# Hillsborough County Florida

## STAFF REPORT

| <b>SUBJECT:</b>                    | PRS 21-0259                          | <b>PLANNING AREA:</b>                     | Riverview |
| <b>REQUEST:</b>                    | Minor Modification to an Approved PD | <b>SECTOR</b>                             | South     |

Figure 1: Off-Site Commercial Locations

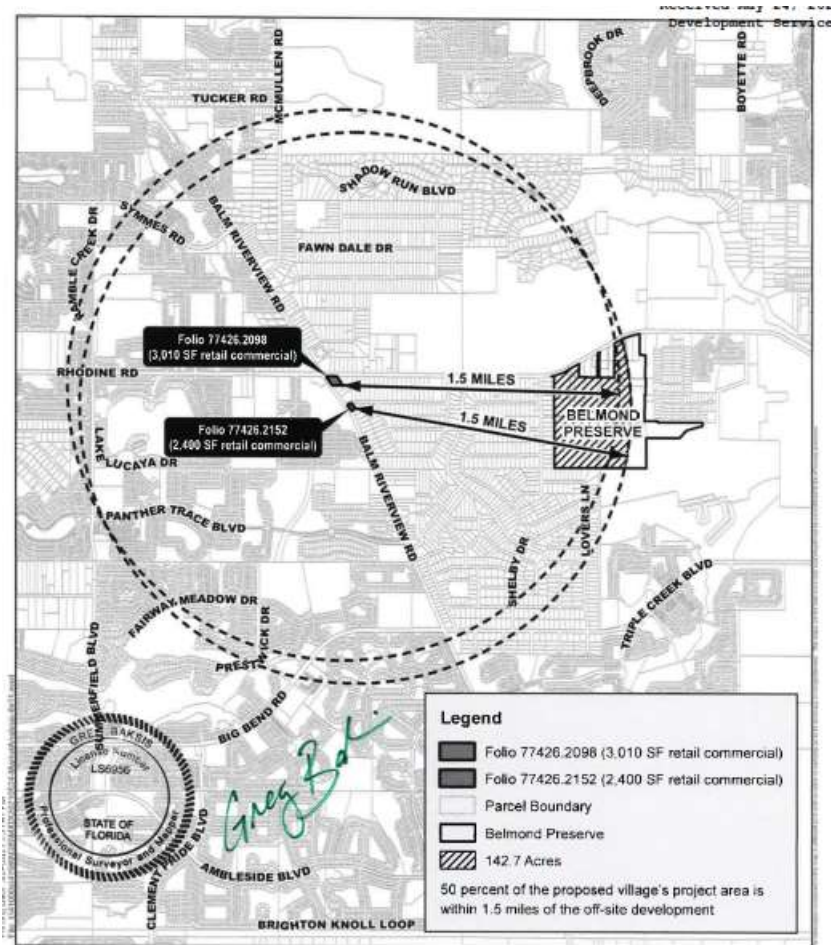
The survey provided by the applicant demonstrates that 5,410 square feet of commercial is located within 1.5 miles of the site (see Figure 1). Both sites are located to the west along Balm Riverview Road and both sites are developed with convenience stores. This survey also shows that this distance is within at least 50% of the area. The sites used for the waiver are not within another planned village and have not been used for the waivers of any other planned village.

Figure 2: Village Node Location

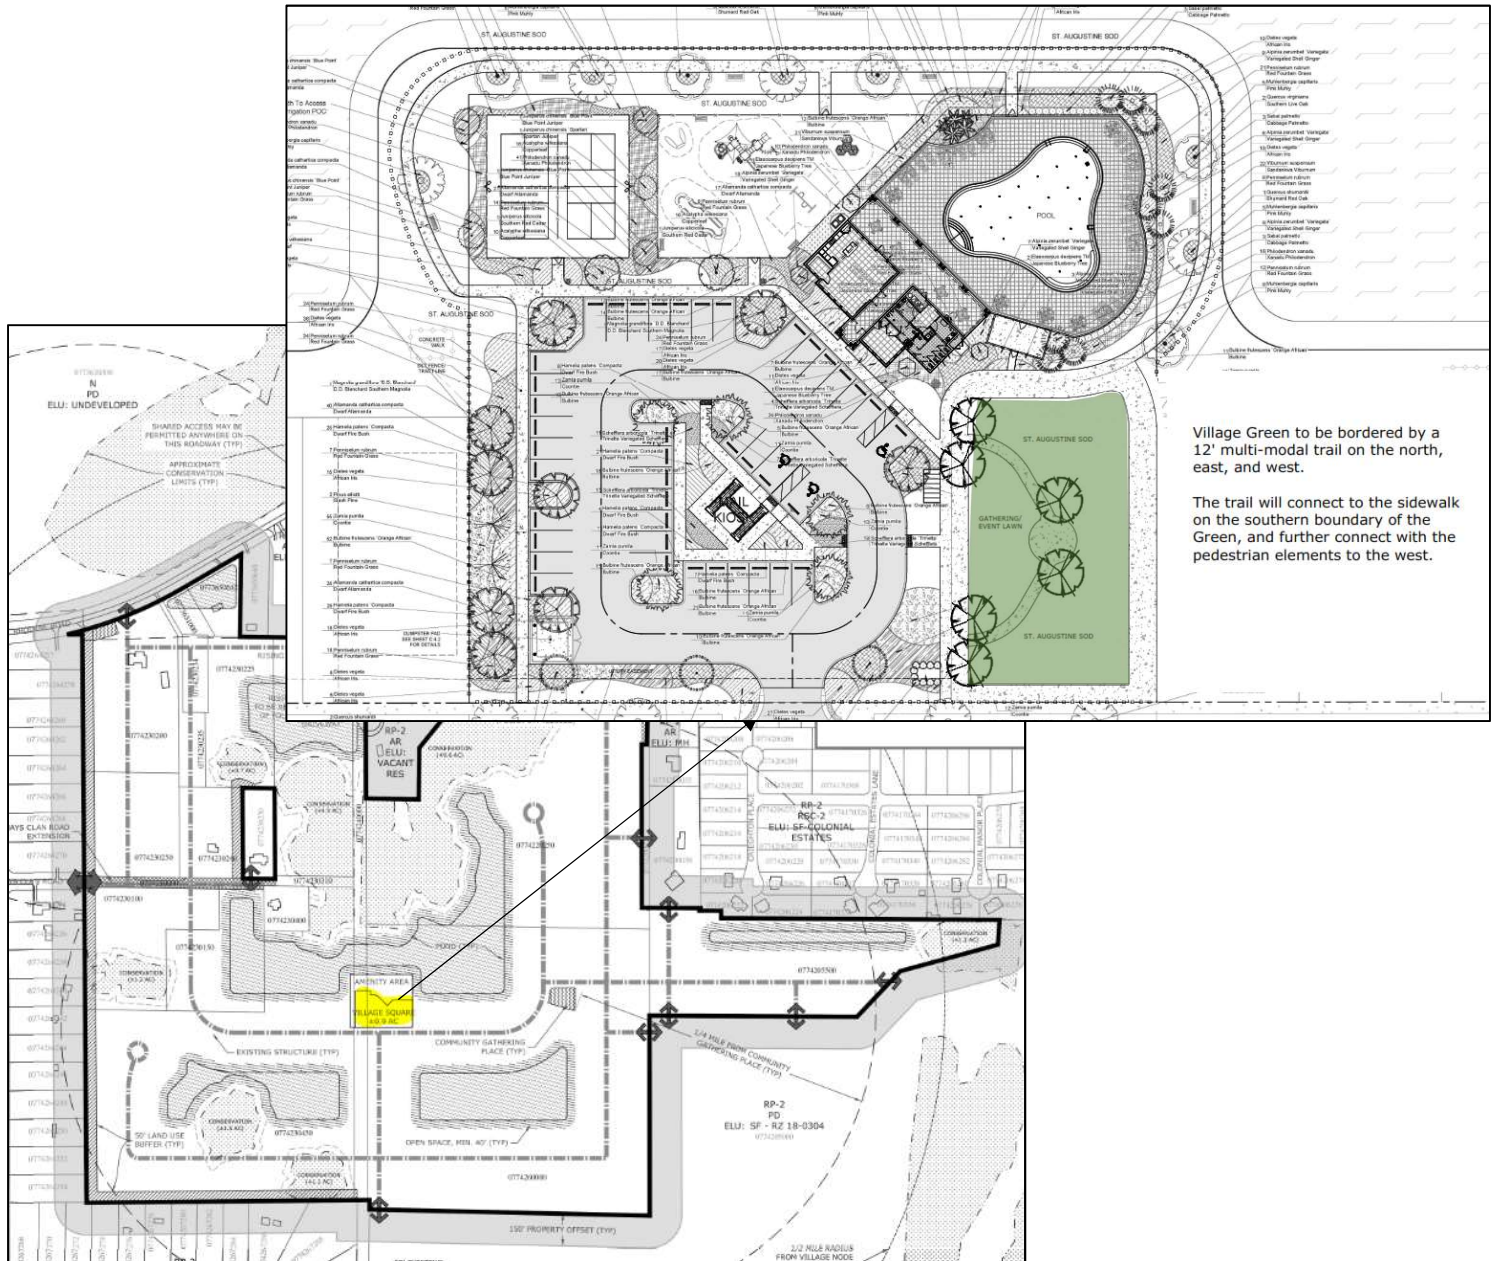
2. **Request to border the Village Square by one roadway.** Per the Land Development Code, a Village Square is required to be bound on all sides by a roadway, whereas a Village Node is not. The approved Village Node location is situated on the north side of the roadway, at a T-intersection (see Figure 2). The Village Square location is now proposed to be located where the Village Node was to be provided. This provides roadway frontage only along the south.

As an alternative to providing roadways along all sides, the applicant proposes to provide a 12-foot wide multi-use path along the west, north and east sides of the Village Square. This will connect to the sidewalk along the southern roadway and to internal sidewalks within the overall amenity parcel area.

The Village Square size of 4,509 square feet will be located at the same size and location as the approved Village Node. The area's size, and its location within the larger amenity area, is appropriate for a utilizing non-vehicular access. The location will continue to be readily accessible (both by car and walking) and centrally located within the project.

Exhibit 5

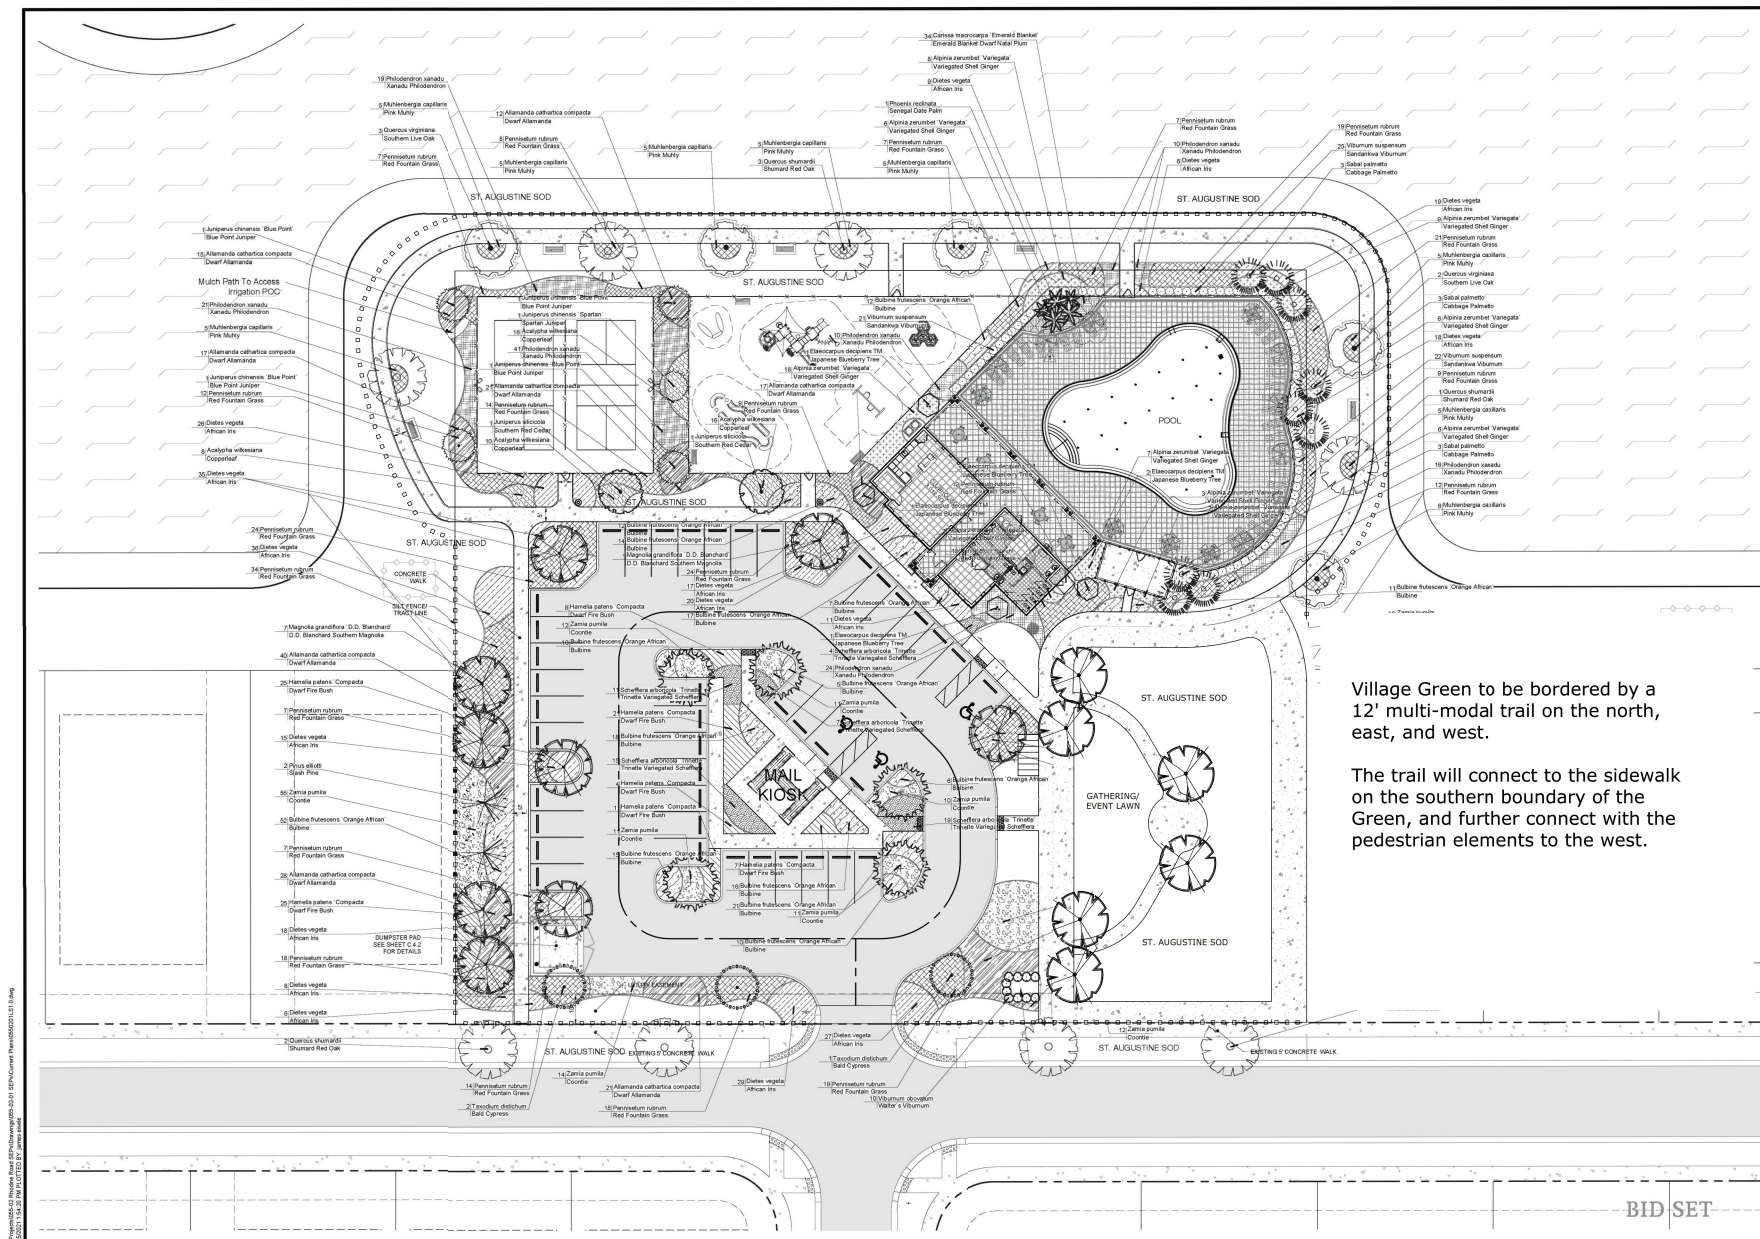
Village Green to be bordered by a 12' multi-modal trail on the north, east, and west.

### *--Eastern Boundary--*

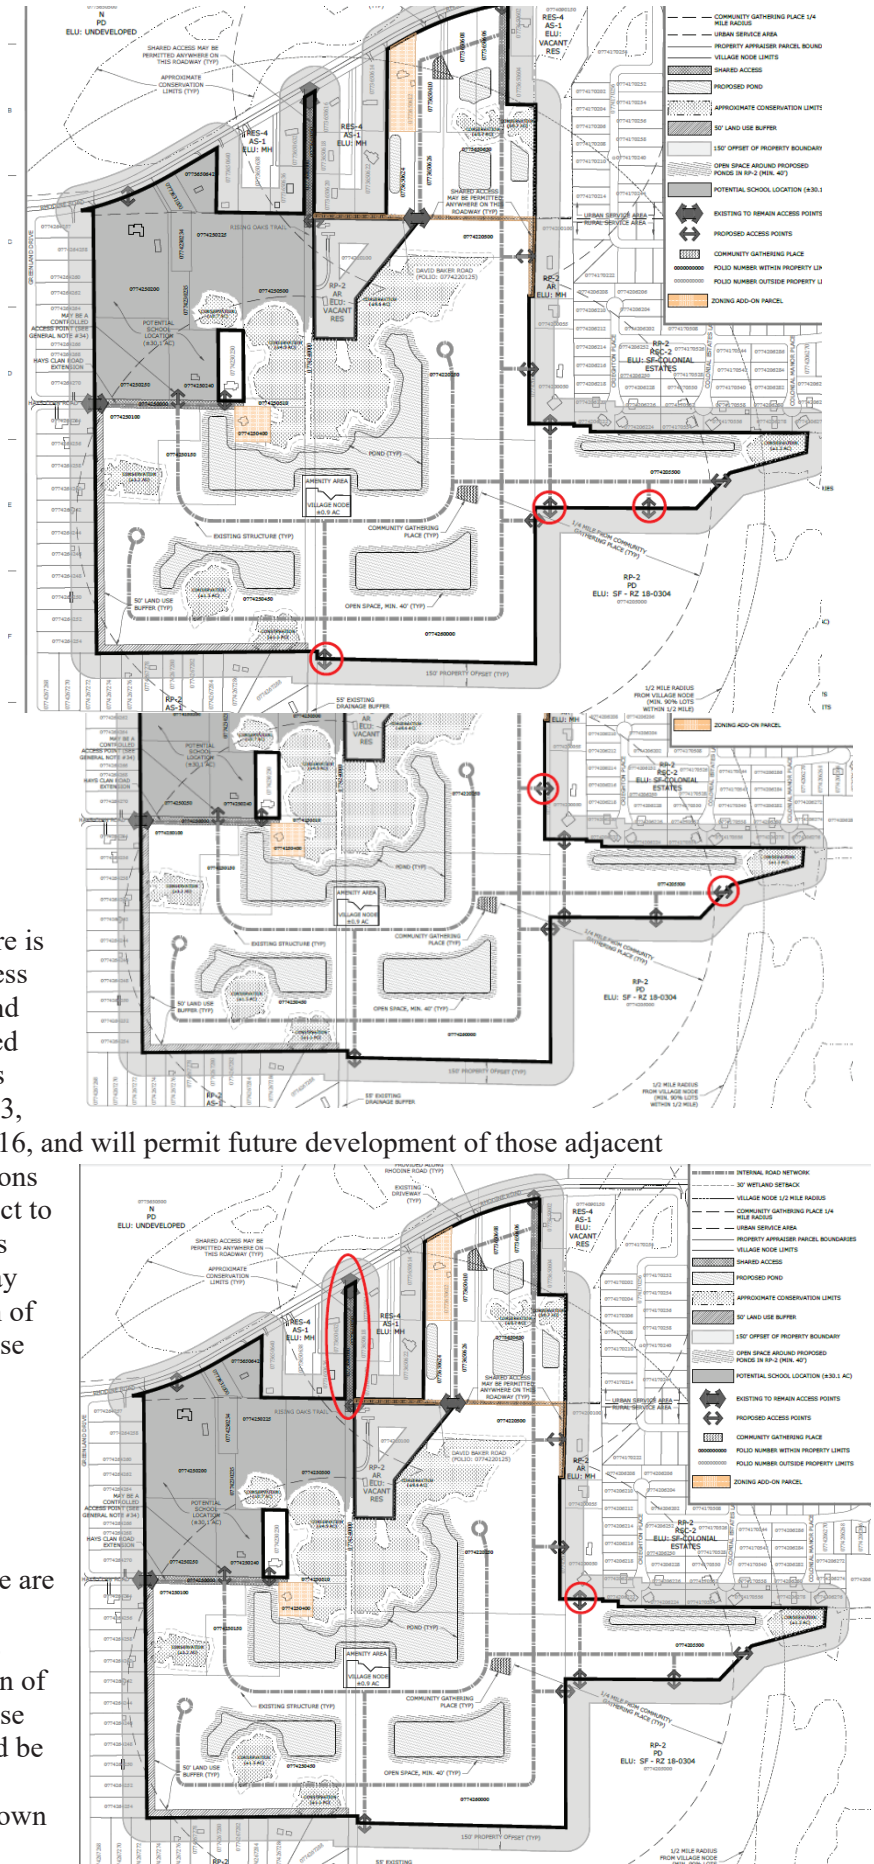
Along the project's eastern boundary, there is one area being designated as a Shared Access area (as indicated by the red oval below) and four additional roadway stubouts (as indicated by the red circles below). The shared access area abuts folio 077365.0602 (which appears to have been recently joined with folio 077365.0604), and will permit future development of that adjacent property (with a Future Land Use designation of RES-4) to connect within that area subject to compliance with Section 6.04 LDC (Access Management) standards. The other roadway stubouts will provide for future continuation of the public roadway network and/or otherwise serve the parcels which they abut.

#### *--Western Boundary--*

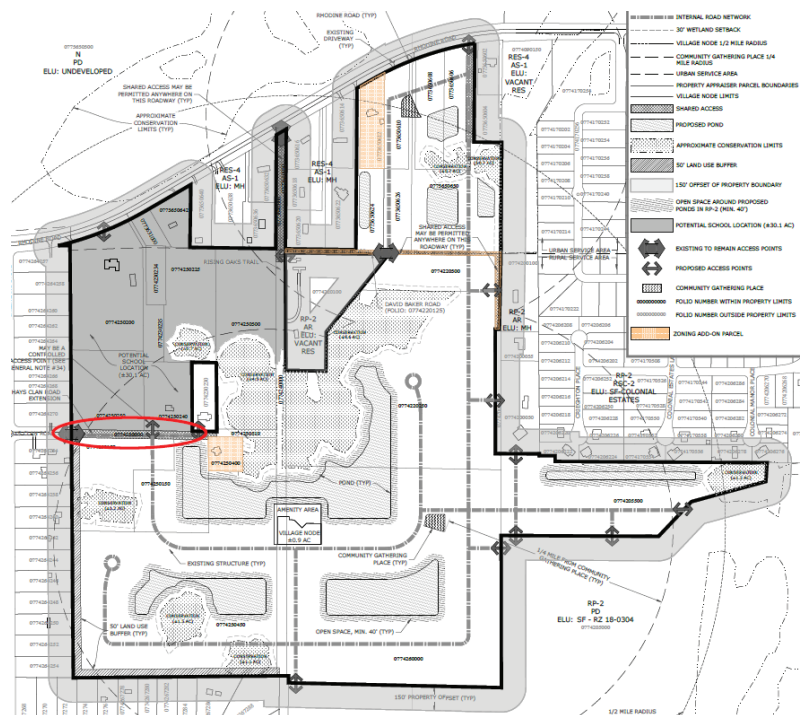
Along the project's western boundary, there is one area being designated as a Shared Access area (as indicated by the red oval below). This corresponds to the proposed Hays Clan Rd. Extension. The shared access area will serve folios 077423.0230 and 077423.0400, and will permit future development of that adjacent property (with a Future Land Use designation of RP-2) to connect with the public roadway system.
